## Rehabilitation of the Yosemite Valley Loop Road Environmental Assessment

### ***What is new with this project?***

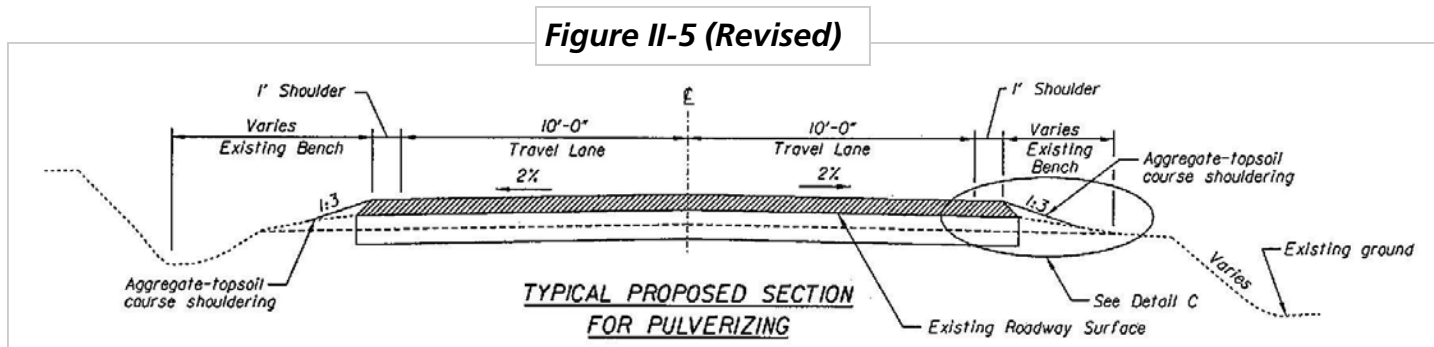
Figure II-1 represents a general depiction of a cross-section of the existing roadway, which includes travel lanes and shoulders. This figure has been revised in response to public comment to better depict the varied nature of roadway shoulders (the graphic presented in the EA had not identified existing shoulder widths).

Figure II-1 illustrates that the widths of existing paved travel lanes vary from 9 to 11 feet; and existing paved and/or unpaved shoulders vary from 0 to 2 feet. The existing road bench and drainage ditches, on either side of the shoulders, also vary in slope, depth, and width.

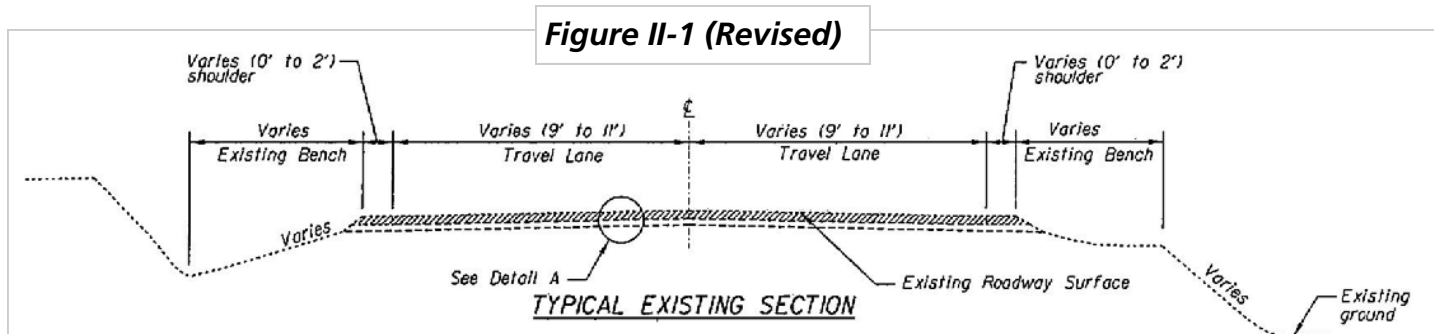
Figure II-5 depicts proposed changes to the Yosemite Valley Loop Road. Travel lane and shoulder widths would be made consistent, where possible, to a standard width of 10 foot travel lanes and 1 foot shoulders. No trees would be removed to achieve these proposed standard travel lane and shoulder widths, nor would the existing road bench be widened to achieve these standard widths. In some locations, the existing roadway width could be made narrower.
